Front curtain

Front Curtain

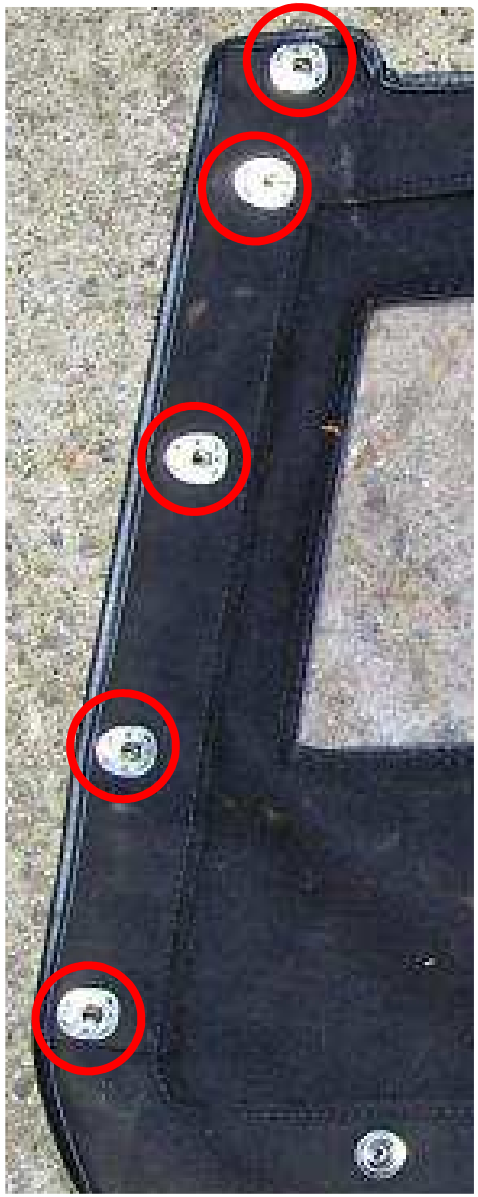
The blue circle on the drawing is from the flap and not the curtain. Seen on the picture to the left. The new curtain uses a little different way.

Front Curtain

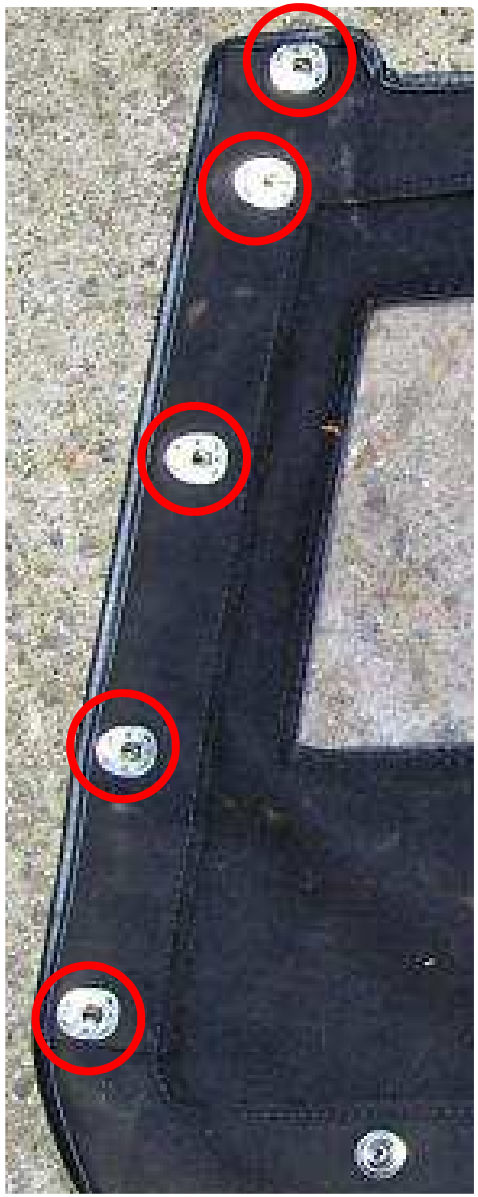
So why are there 2 length?

There seems to be a difference between the old and new version.
The old flap must have been fixed on the insight only, whereas at the new one has a v-cut to allow fixing it to the outside of the roof ribs.
Furthermore it seems that the old version, unlike the new one, had the flap fixed to the curtain with the red dot.

Front Curtain

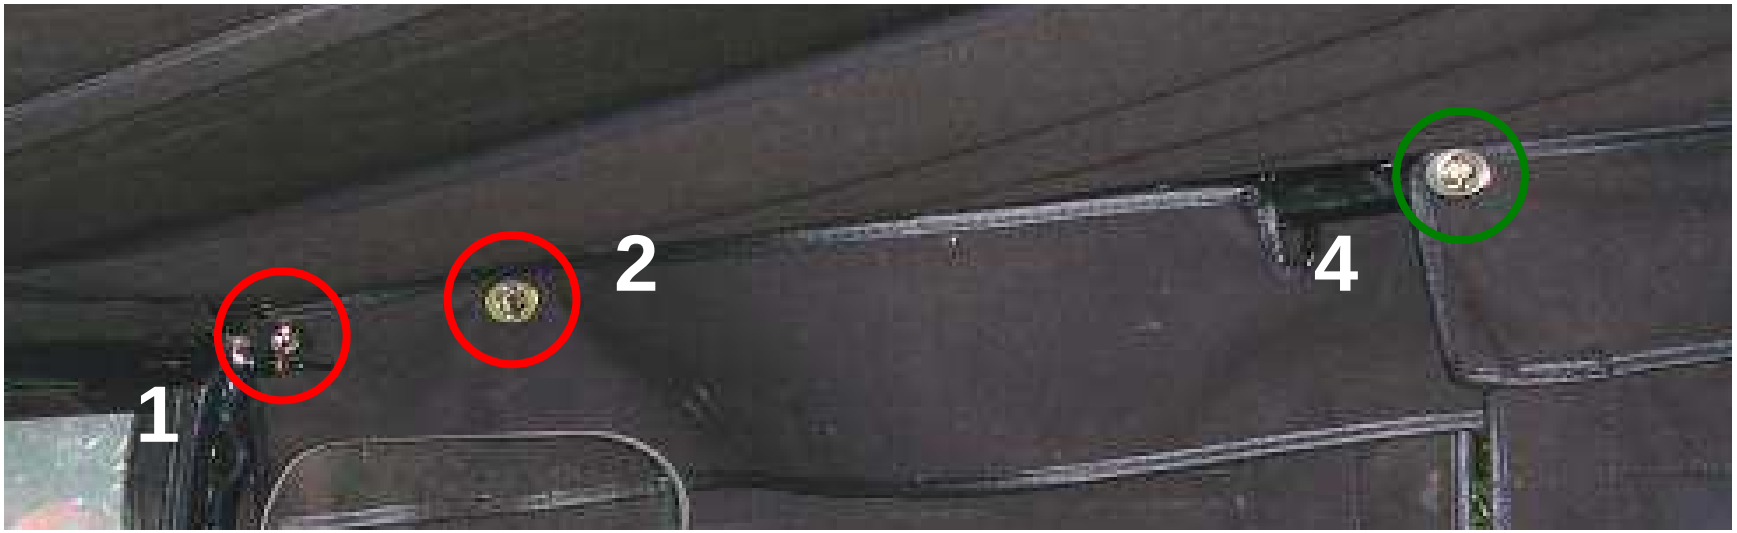
Here it’s clearly shown that the last fastener on the flap is fixed to the outside of the roof rips. This will have the advantage that rain and wind will kept to the outside of the middle curtain.

Front Curtain – Roof ribs

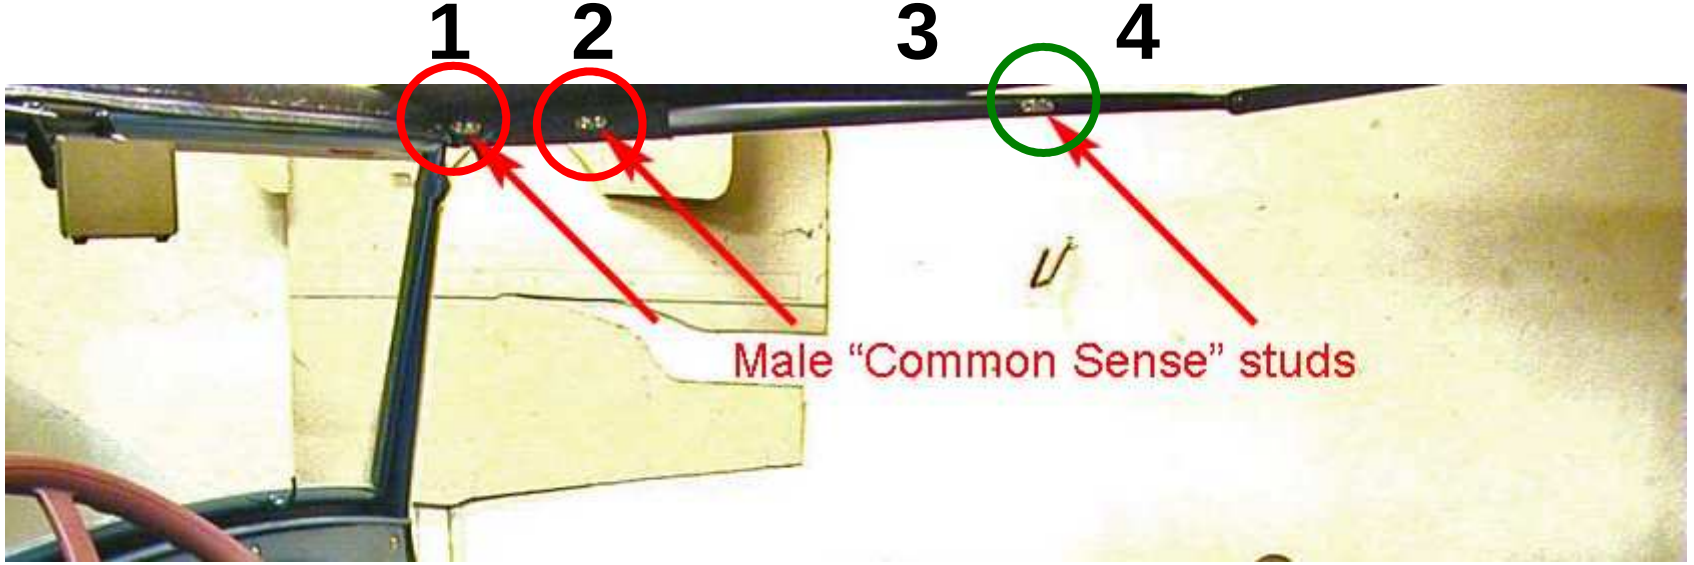
Unclear to me is, what kind of fastener is used. Looking at the picture before it must be one of those:

Nr. 1 & 2:
Hold the front flap

Nr. 3 (not seen, as it is on the outside):
holds the front flap

Nr. 4:
This is fastener is on the inside of the frame, and fixes the middle curtain

Middle Curtain

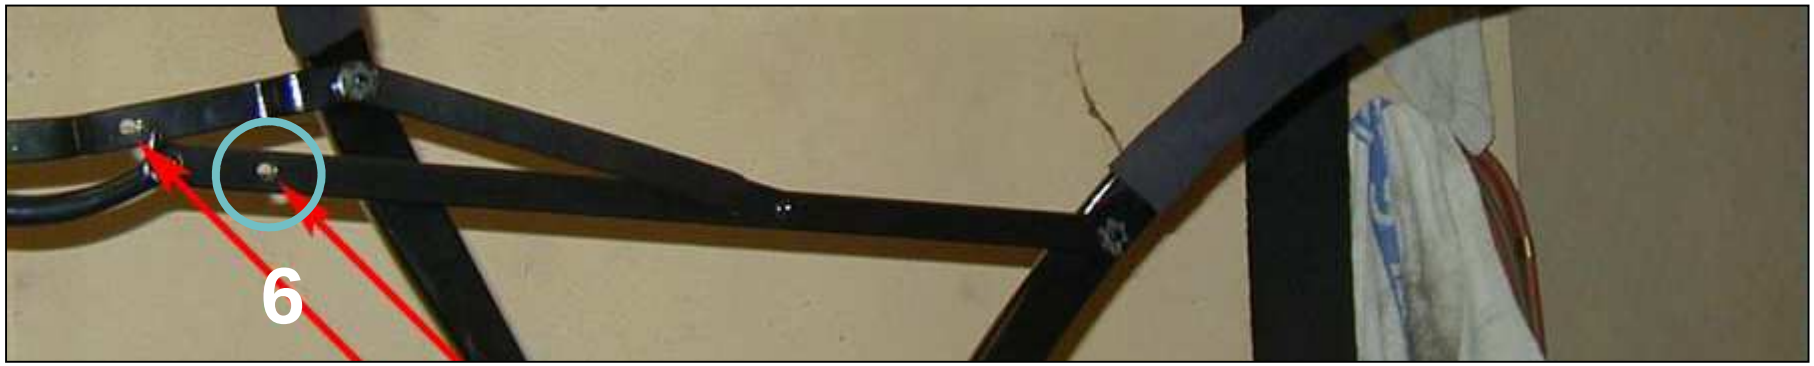
It seems as if there are two versions here as well. The fasteners in red seem to be different.

The little triangle gives room for the screw that holds the front frame

Nr. 6:
Which one?

Nr. 6: The hole in the roof frame where the cinch post type studs fits into

Back Curtain

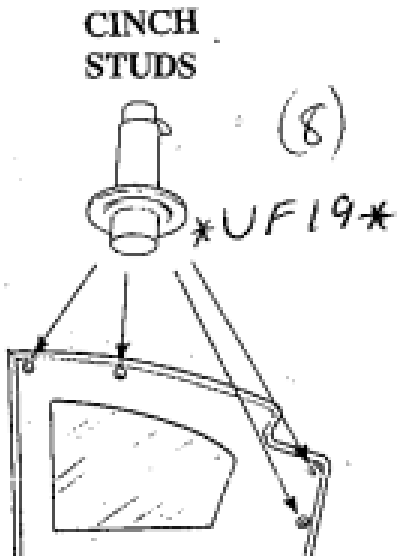
It seems that the drawing uses a little different version, with one less hole.
The fasteners are fixed to as follows:

7	Top rib	10	Canvas
8	Canvas	11	Canvas
9	Roof ribs

Back Curtain

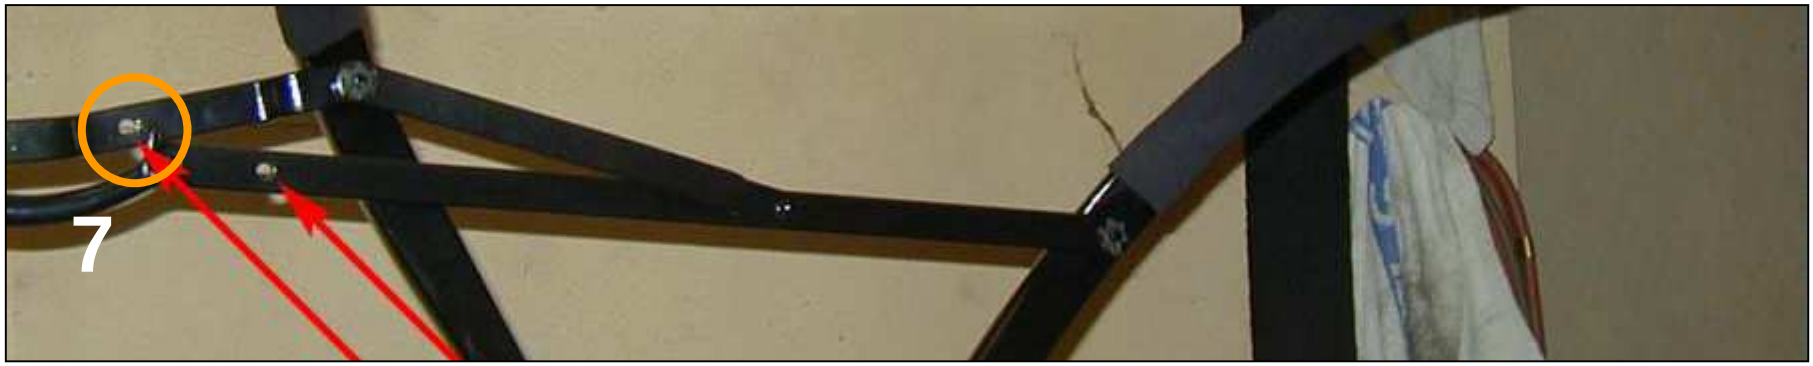
Holes in the roof frame for Cinch post type

Nr. 9:
Is fixed to a chinch post on the special flap, better visible on the next picture

Back Curtain

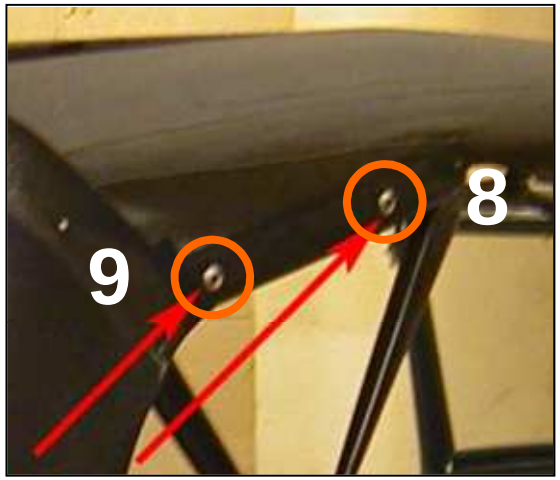
Nr. 8 & 9:
Are fixed to a special flap (not the top canvas) and are facing inwards.

Back Curtain

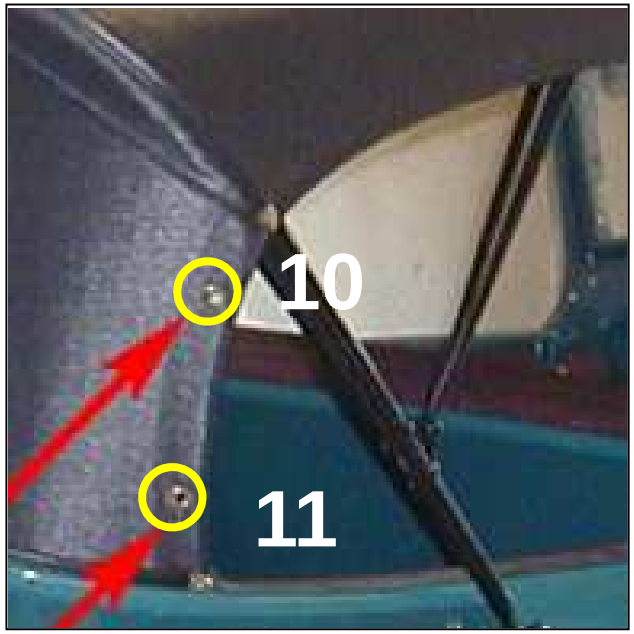
Its not the best picture because the fastener in front of the rip is misleading.
Its not fixed to the rip, but to the flap behind it.

Body sockets

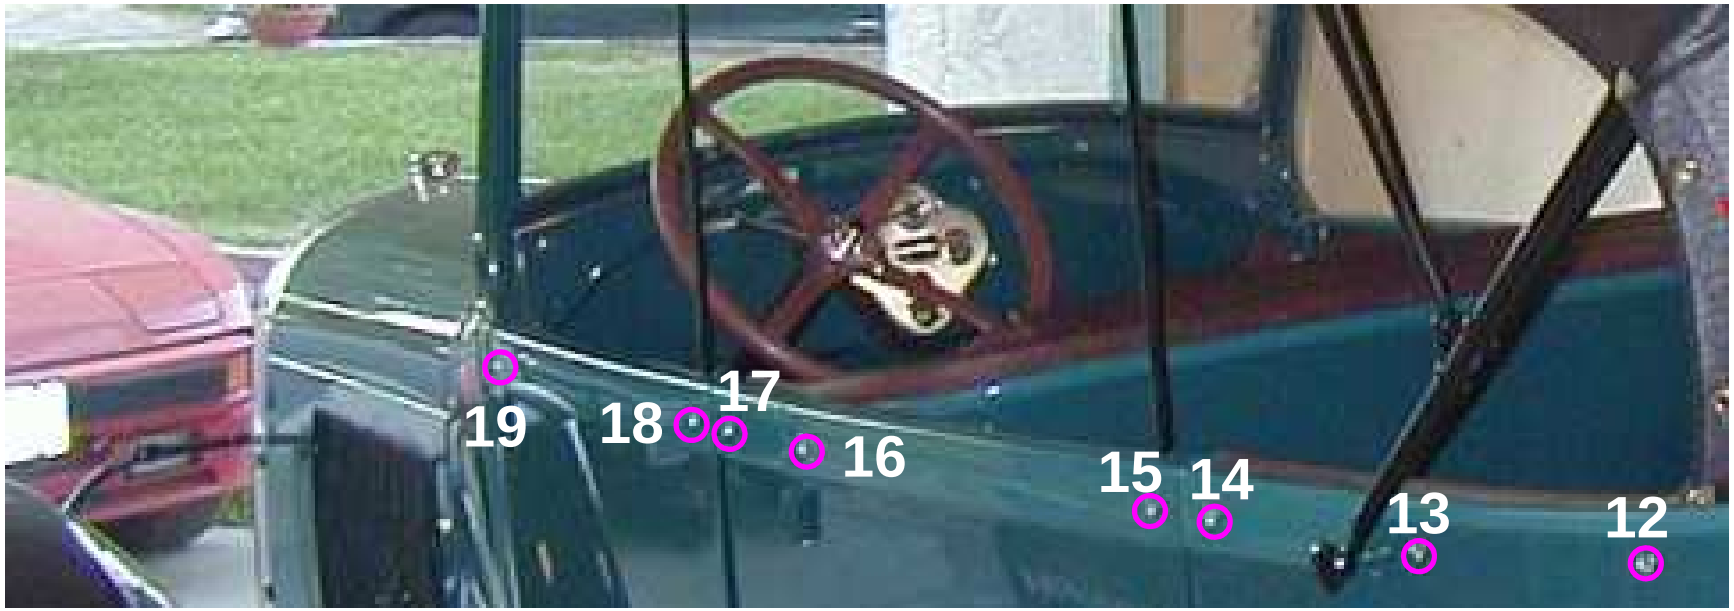
12	Back curtain
13	Back curtain
14	Back curtain
15	Middle curtain
16	Middle curtain
17	Middle curtain
18	Front curtain
19	Front curtain
